9.1.1. DA0753-2021 - 13-15 Russell Street, Invermay Planning Scheme Assessment - 30 June 2022.....	5
9.1.2. DA0753-2021 - 13-15 Russell Street, Invermay - Plans to be Endorsed - 30 June 2022.....	27

TITLE: DA0753/2021 - 13-15 Russell Street, Invermay - Community Meeting and Entertainment - Partial Demolition of the Existing Building; and Residential - Construction of a Dwelling

FILE NO: DA0753/2021

DRAWING TITLE
SHADOW DIAGRAMS

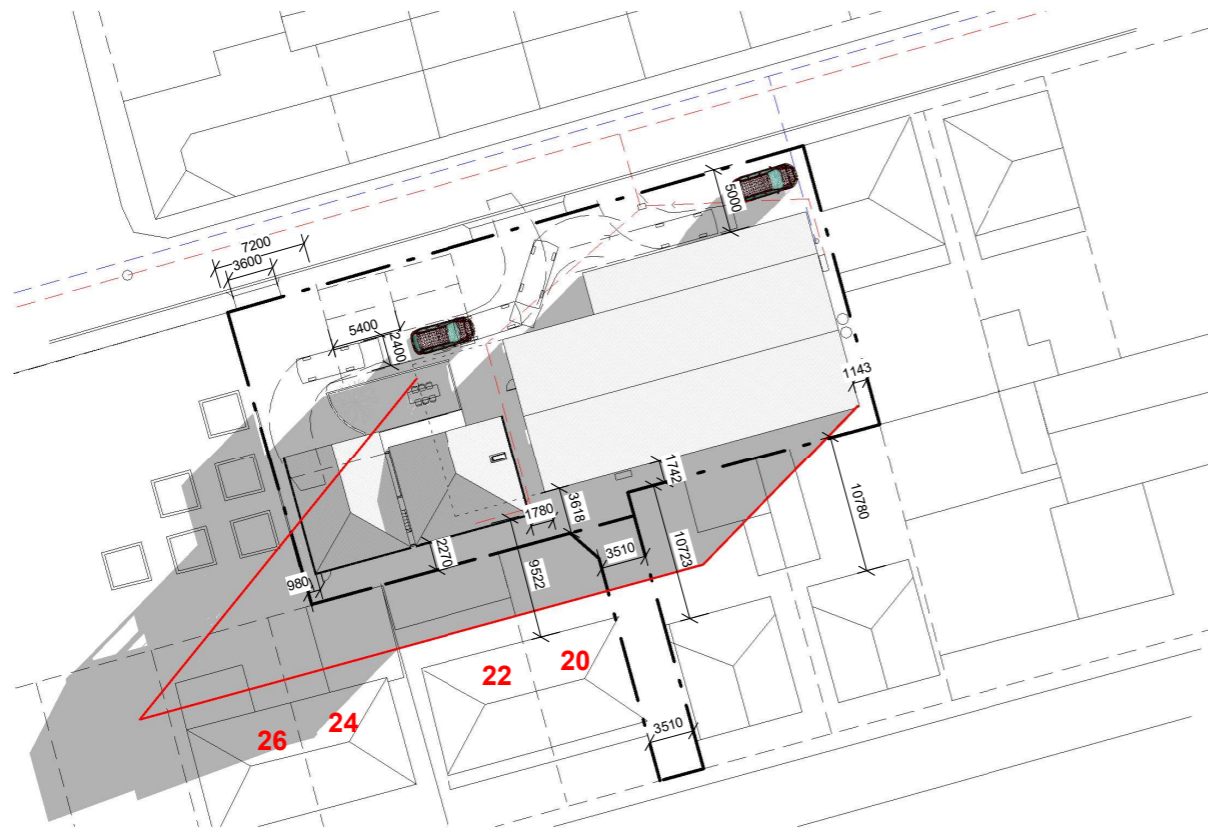
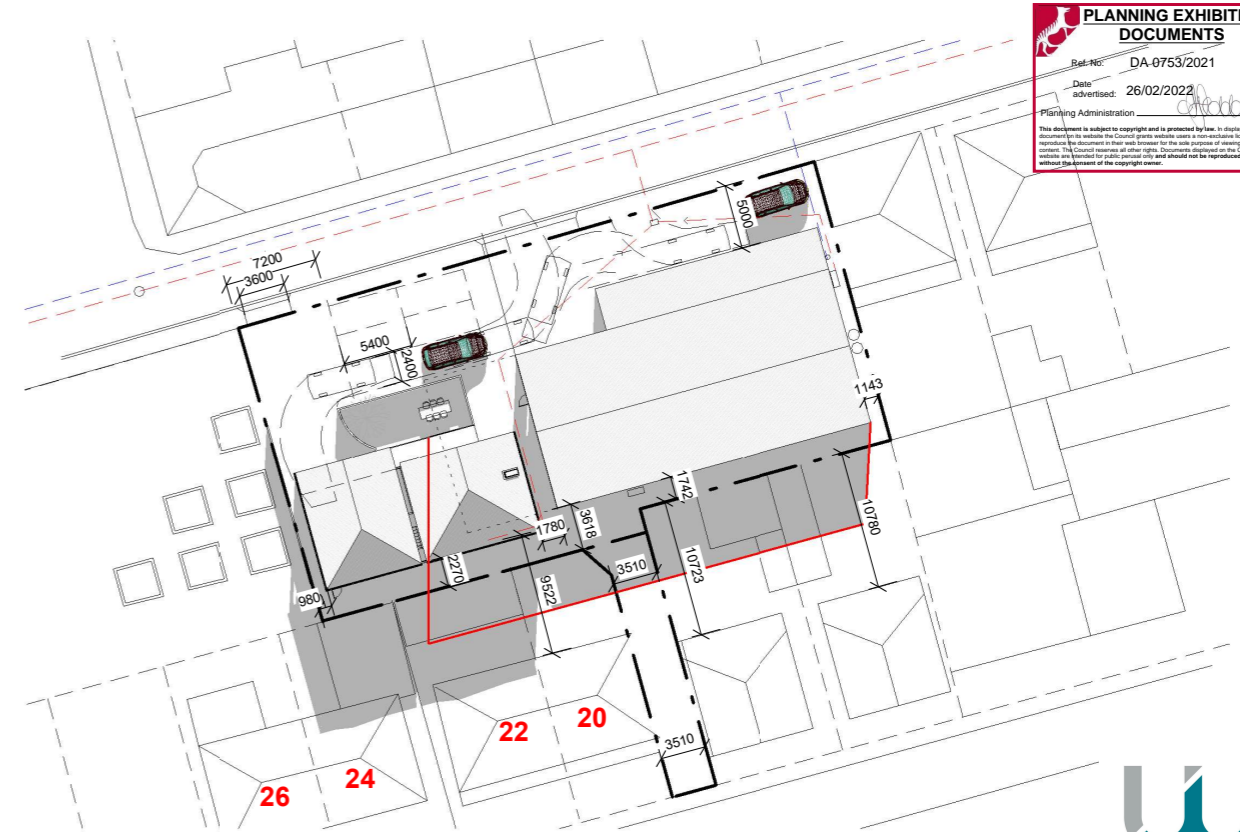
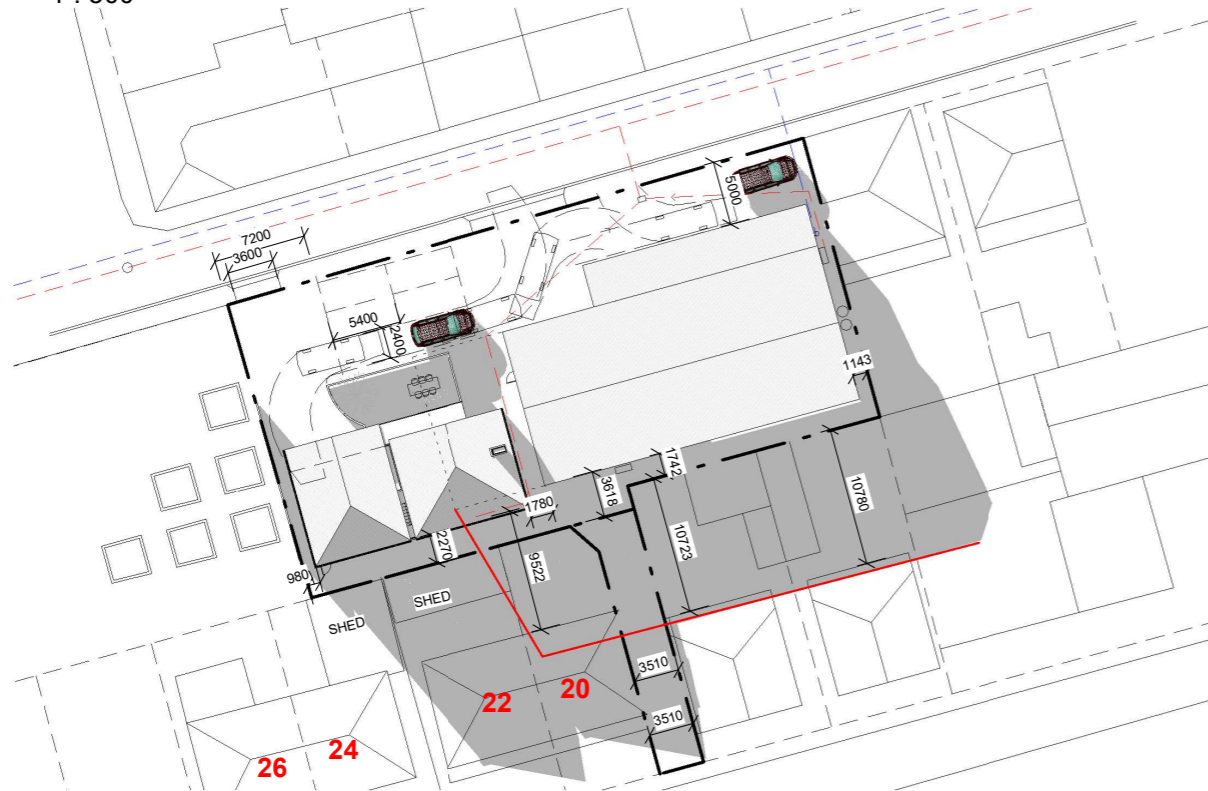
11.4.3 P1 as it will allow for an unreasonable loss of sunlight reducing the sunlight, we will experience to 3 hours according to the plans simulation for June 21st. this is an increase of at least 6 hours of shadow, the effect of this will be felt very strongly. The sunlight at our property is very Important as it greatly effects the temperature control of the house, the dampness levels and the overall mental health of our household. The majority of our natural lighting comes from our back window which will now be greatly impacted and blocked out for the majority of the day. As well as this the new development will be bringing a major loss of privacy as our backyard, loungeroom and adjoining rooms will no longer be private areas. the visual impacts will also not comply with 11.4.4 P1 as it will take up a majority of our skyline. The shadowing and visual impacts are my biggest issues as the effect it will have on my and several other residents in Bedford St mental health will be drastic. Losing crucial hours of sunlight will turn our once sunny and warm home dark and gloomy. My final issue with the upcoming development is that the placement of the west boundary fence which is marked to be 1.8 m high and 13.3 m wide which will be imposing on the community garden. It does not comply with 11.4.6 A1 as currently it is to tall to be made of a single material as proposed. It also does not comply with 11.4.6 P1 B – E, it is a floating fence, it does not serve a purpose for security as It does not enclose or protect the property. It does not consider or fall in line with the surrounding fences and will block the view of people within the community garden in regard to car parks and traffic flow. It also detracts from the actual quality of the Space of the garden as, making the barrier be so close to the garden beds will make upkeep difficult and removes the beautiful open space feeling of the gardens themselves. The loss of feeling of community in this area will only exacerbate my concerns in regards to mental health and Community wellbeing in the area. After several points in the plan that don't meet the standard at the very least I will be expecting a meeting as the current state of the development will become an ongoing issue in our happy community

- (a) not unreasonably cause loss of amenity through:
 - (i) Overshadowing - the applicant has provided shadow plans demonstrating the shadows from the dwelling if compliant with the acceptable solution and the shadows from the proposal. From these it is apparent that the proposal will cast additional shadow into the rear yards of both 24 and 26 Bedford Street on 21 June, however, by midday such shadow will be clear of number 26 and little more than the shadow of the existing shed at 24 Bedford Street. Given the residential zoning of the site, some level of residential development should reasonably be expected at some point in time and considering the flooding overlay, such residential development should similarly be expected to be two storey. Consequently, some level of additional overshadowing should also be reasonably expected. The additional shadow plans provided by the applicant demonstrate that the difference in overshadowing from proposed building to what would be permitted within the building envelope is minor.
